Zaber & Zubair Fabrics Ltd (Extension)

18th October 2021

Observations

STRUCTURAL DESIGN REPORT OF FINISH GO-DOWN

Sag rod Layout plan- Sag rod was not found at site at marked location but shown in as-built drawing.

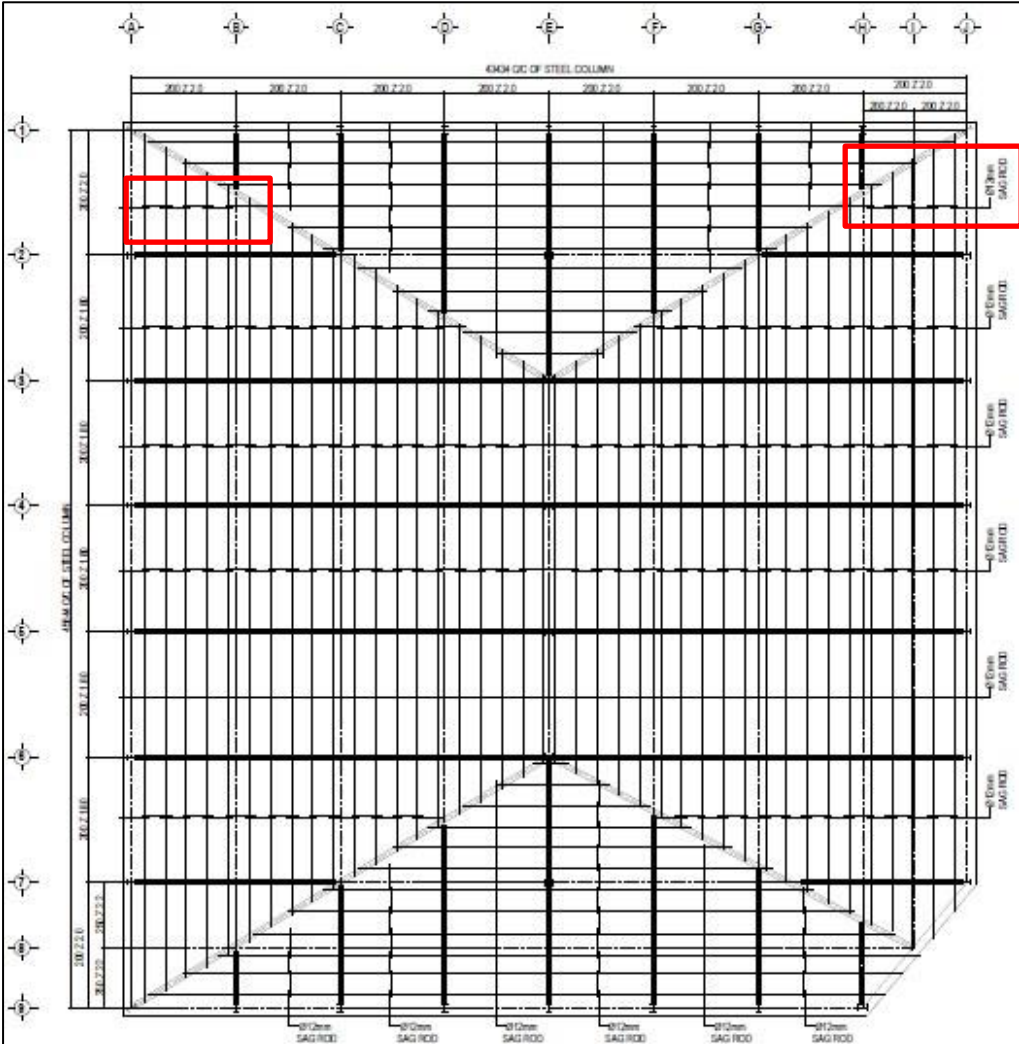
Sag rod found missing at site

Factory engineer is required to survey the whole structure and update the as-built drawing.
